ADDENDUM NO. 02

SYRACUSE HANCOCK INTERNATIONAL AIRPORT

RECONFIGURE TAXIWAYS C, F, B, E, AND G

June 12, 2018

| 6/5/2018 | ADDENDUM NO. 1: ADDED EXISTING CONTOUR LABELS | JPM | |
|---|--|--------------------------|----|
| <p>SYRACUSE REGIONAL AIRPORT AUTHORITY CITY OF SYRACUSE, STATE OF NEW YORK RECONFIGURE TAXIWAYS C, F, B, G, AND E GRADING & DRAINAGE PLAN (SHEET 4 OF 4)</p> | | | |

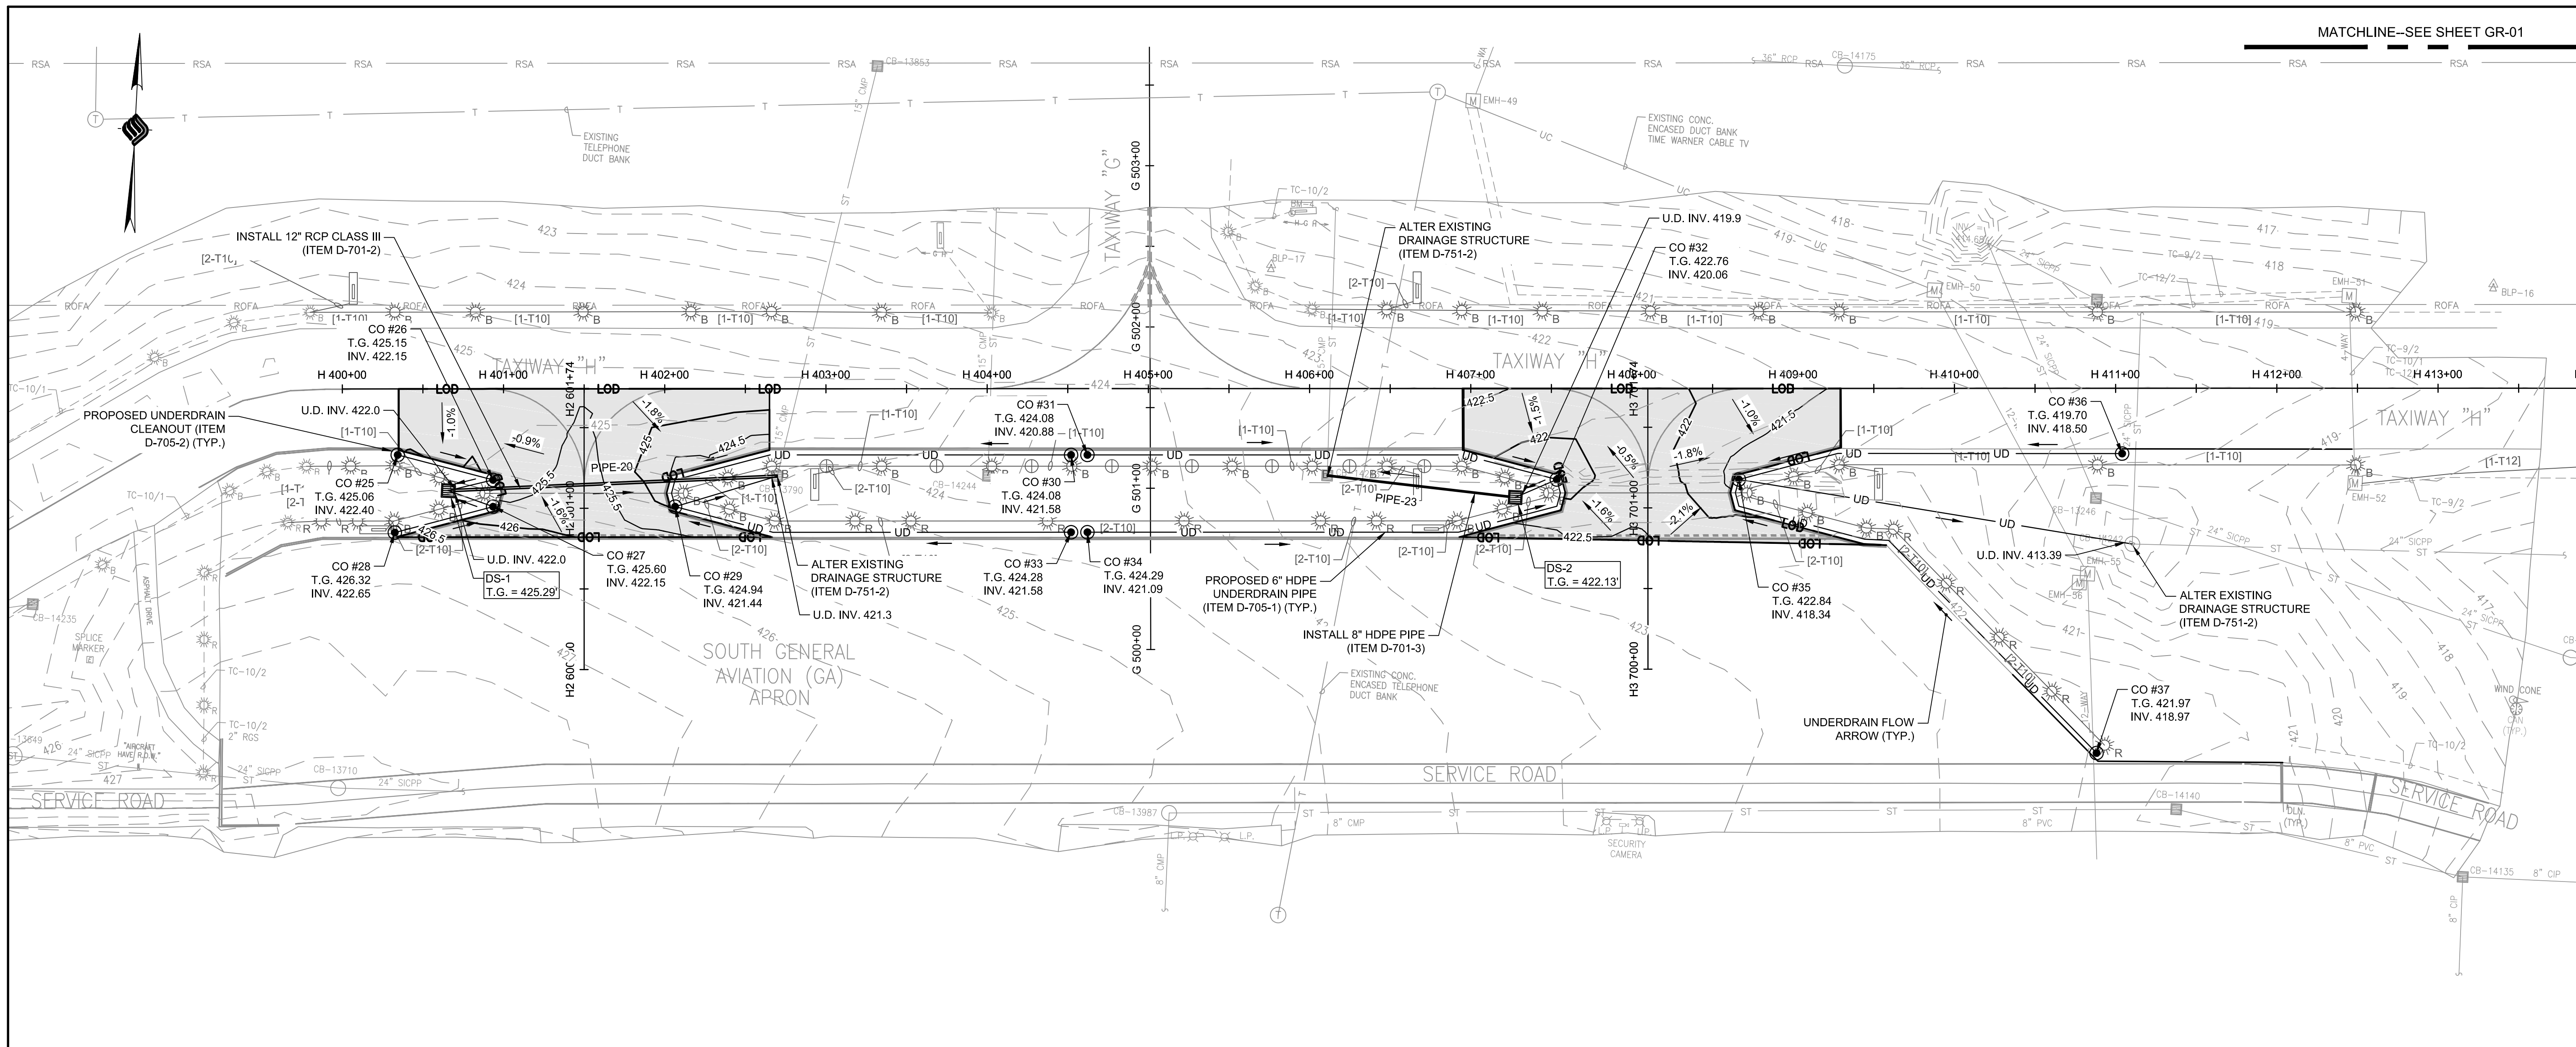
| 6/5/2018 | ADDENDUM NO. 1: ADDED EXISTING CONTOUR LABELS | JPM | |
|---|--|--------------------------|----|
| 6/11/2018 | ADDENDUM NO. 2: ADDED UNDERDRAIN INVERT VALUES | JPM | |

MAJOR FRAME & COVER/GRATE ADJUSTMENT - RAISE 2

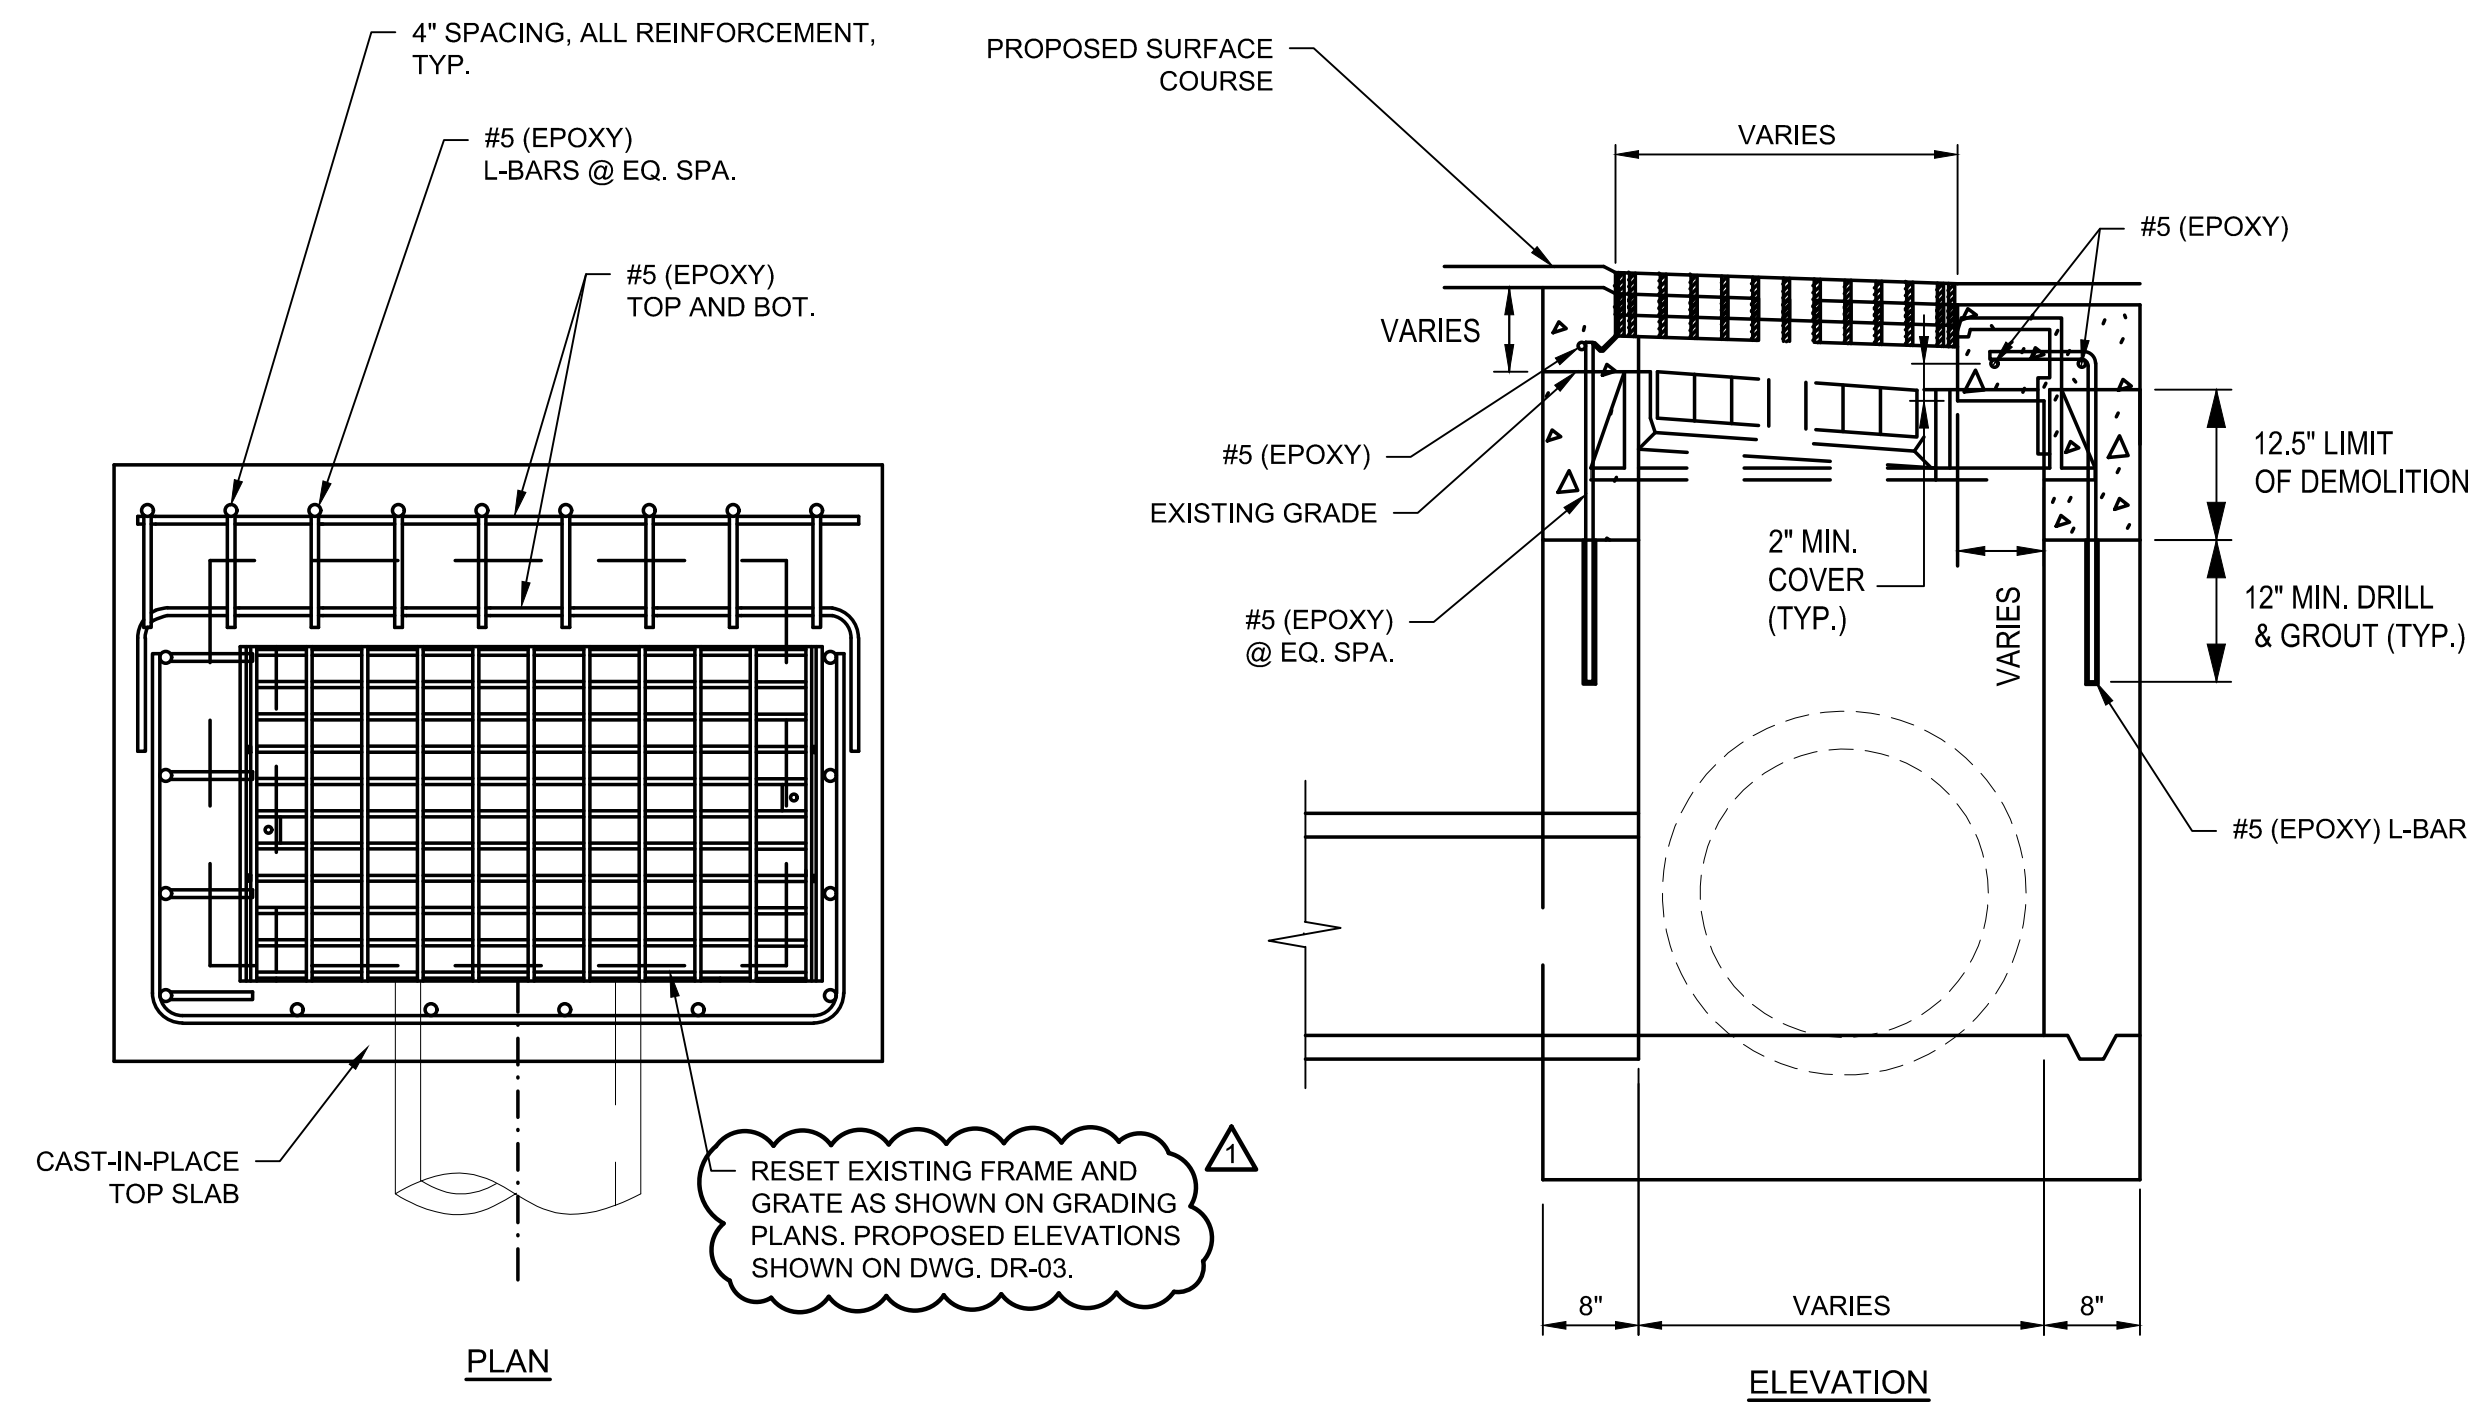
Q2: On plan sheet 30 (DR-01), detail 2: It says, “new frame and grate as indicated on grading plans”. No frame and grate types are indicated on the grading plans. Are new frames and grates required for these alters? If so, what size and style are required?

A2: New frames and grates will not be required for these drainage structure alterations. The existing frames and grates shall be removed, stored, and reset once the alterations are complete. Proposed elevations shall be as indicated on sheet DR-03. Detail #2 on sheet DR-01 has been updated.
